TOWN AND COUNTRY PLANNING ACT 1990 CONSULTATION RETURN: SCC/0045/23SE

PROPOSAL: Construction and operation of an anaerobic digestion facility, associated infrastructure and new access road, connecting pipeline and covered digestate lagoons.

LOCATION: Land to the north of Spring Grove Farm, Withersfield, Suffolk, CB9 7SW

Distribution of Interested Purpose Grown and Residue Feedstock Counterparties Spring Grove Green Power:

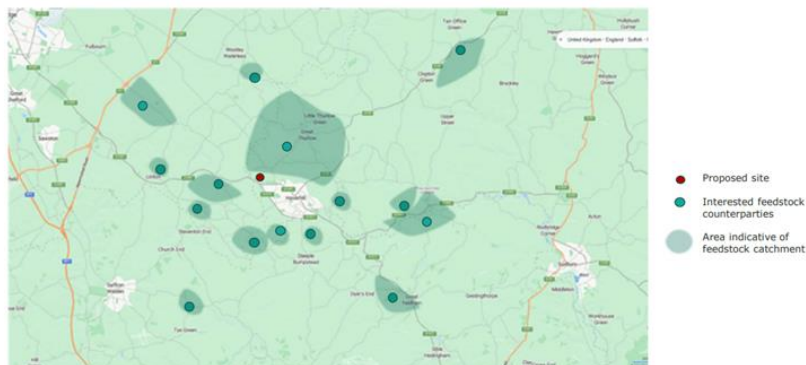
We have reviewed the Transport Addendum and note 4.3 which states that operational trips are split with 75% assigned to the west and 25% assigned to the east. This split was not included in the earlier Transport Note. There is no clarification or data to evidence why there is a such a large disparity between the west and east direction. The 75%/25% split does not appear to be supported by the recently submitted Spring Grove Proposed Feedstock Availability Analysis which provides an indicative plan showing the parties that may utilise the facility (see snip below).

The plan suggest that the majority of potential clients will be generally to the east of the site which does not support the assigned 75%/25% trip direction. This is an important consideration, as the split is used on to forecast the queue data and derived junction modelling. This data is then used to support the assertion that the proposed access design will have a negligible impact on the operation of the local highway network because the queue lengths for vehicles waiting to turn right into the site would be less than 1 vehicle during the peak periods.

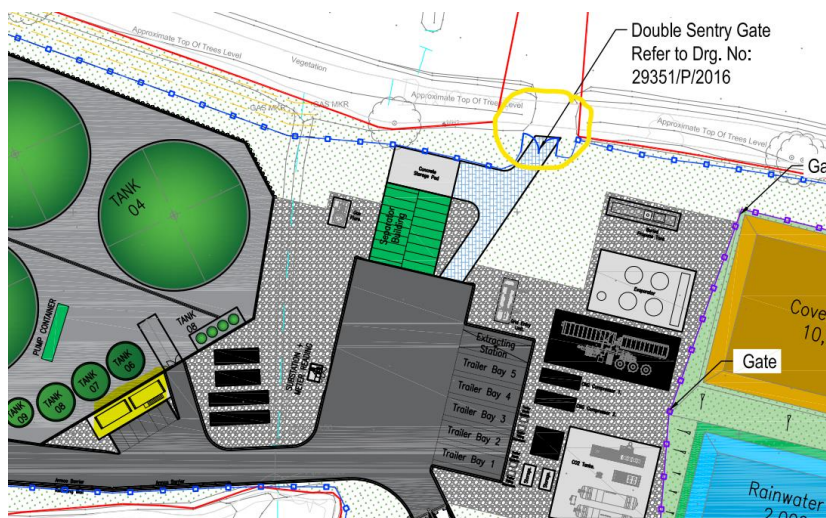
The Distribution of Feedstock plan indicates the location of Interested feedstock counterparties but a number of these are more than 10 miles from the development site. It also states that within a 10-mile catchment area there is a reasonable expectation that there is potential for 2,000,000 tons. The snip below is taken from the Spring Grove Proposed Feedstock Availability Analysis page 1 with our highlights added.

- Within a 10-mile initial feedstock catchment radius, assuming total farming land use is given over to a single crop, we might reasonably expect there to be the potential for c.2,000,000t of maize, whole crop silage or grass. Alternatively, there could also be the potential for 250,000t of straw.

We would like to understand better the potential for site operational growth, so that we can have confidence that the stated number of trips will remain broadly stable. Is there a planning condition that would prevent growth up to the theoretical maximum potential?

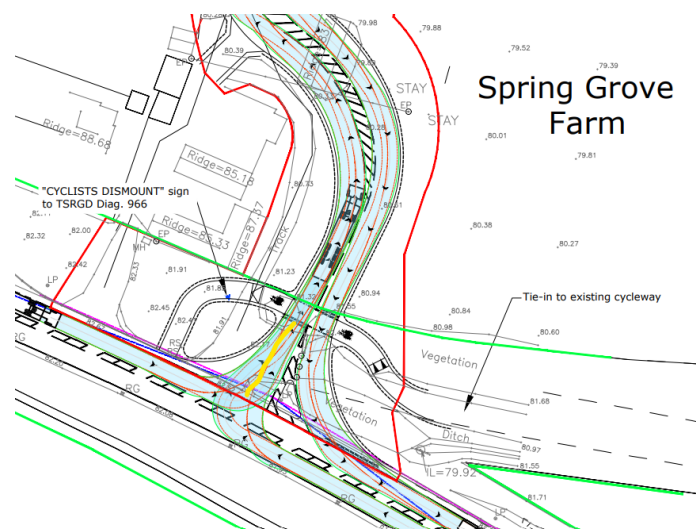
We note the HGV track plan Drawing No. 2401110-TK01 which evidences that there is sufficient space for HGV to manoeuvre in and out of the trailer parking spaces as long as that manoeuvring space is not blocked by parked vehicles. Will HGV’s need to manoeuvre in the vicinity of the Ark Clamps 1 – 3 in the western part of the site or will that space be reserved for site operational vehicles?

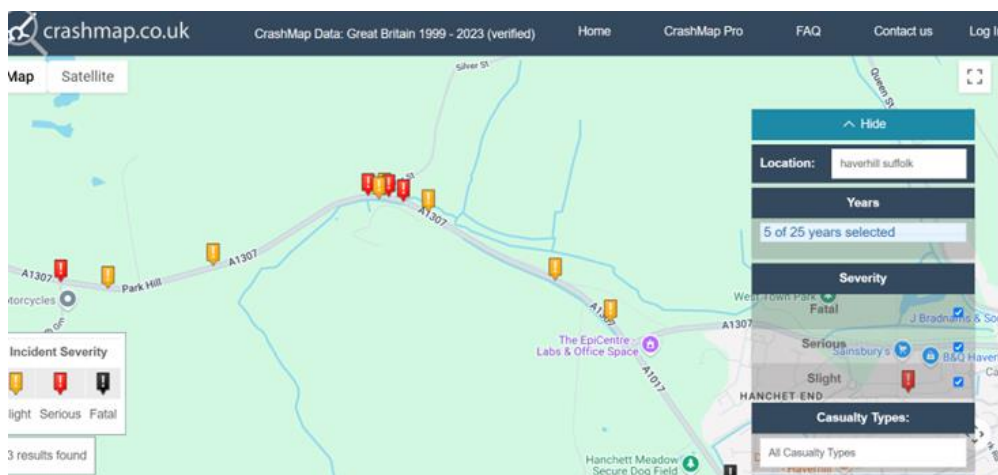
The snip below is taken from CrashMap and shows the number of incidents that happened on the A1307 in the 5-year period 2019 to 2023. We note with concern the cluster of accidents at the Silver Street junction. The application has not evidenced that a similar pattern of accidents will not occur at the proposed access junction.

We also note the road verge High Casualty Route sign which is a very short distance from the access to the development site.
